**CITY PLAN COMMISSION****THURSDAY, APRIL 10, 2025****FILE NUMBER:** S245-125**SENIOR PLANNER:** Hema Sharma**LOCATION:** Simpson Stuart Road, east of Bonnie View Road**DATE FILED:** March 12, 2025**ZONING:** CR**CITY COUNCIL DISTRICT:** 8**SIZE OF REQUEST:** 3.21-acres**APPLICANT/OWNER:** Peak Development, Mount Tabor Baptist Church Inc.

**REQUEST:** An application to create 3 lots ranging in size from 1.04 acre to 1.13 acre from a 3.21-acre tract of land in City Block 6866 on property located on Simpson Stuart Road, east of Bonnie View Road.

**PRELIMINARY PLAT  
ON STUART ADDITION**  
**LOTS 1-3, BLOCK 6866**  
ACRES OF LAND IN BLOCK 6866 SITUATED IN THE  
B. RICHARDS SURVEY, ABSTRACT NO. 1192,  
CITY OF DALLAS, DALLAS COUNTY, TEXAS  
CITY PLAT FILE NO. 5245-125  
CITY ENGINEERING NO. \_\_\_\_\_

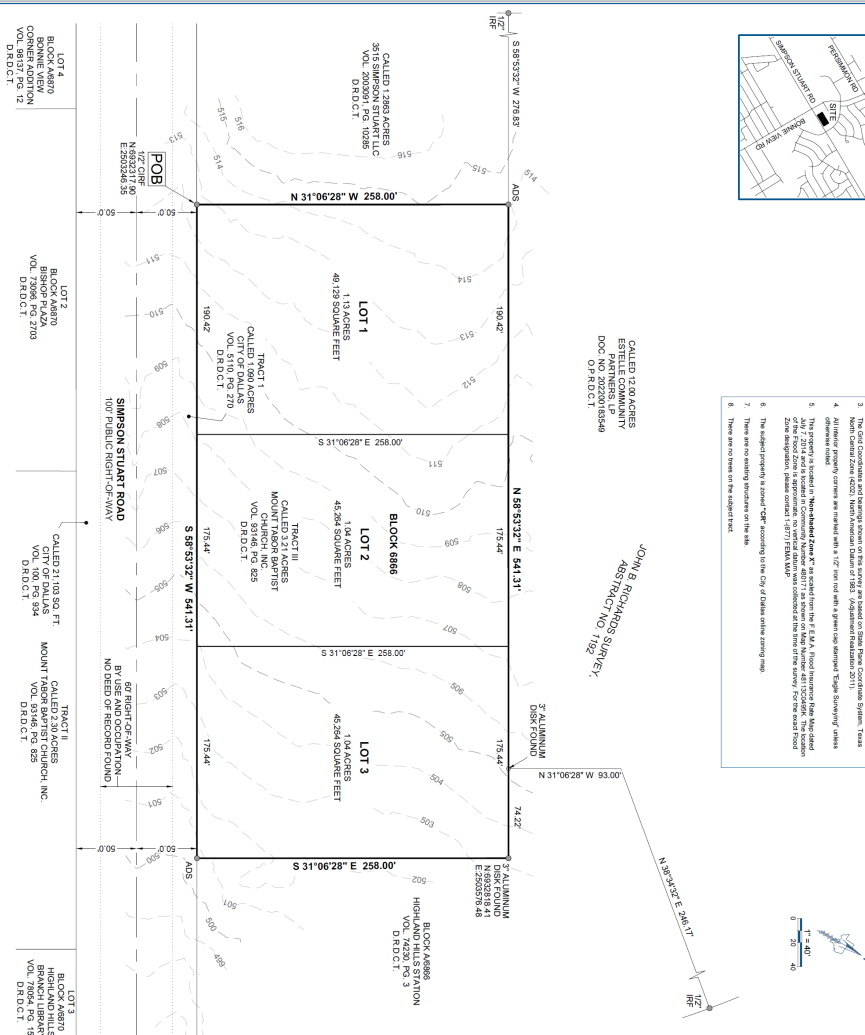
15. Prior to final plat, submit a completed final plat checklist and all supporting documents.
16. On the final plat, show recording information on all existing easements within 150 feet of the property.
17. On the final plat, show abstract line location.
18. On the final plat, show easements in Volume 105, page 1459, deed records, Dallas County, Texas.

23. Prior to final plat, compliance with City's street lighting standards including illumination standards, material, installation, and activation per Street Design Manual.
24. On the final plat, identify the property as Lots 1 through 3 in City Block A/6866.
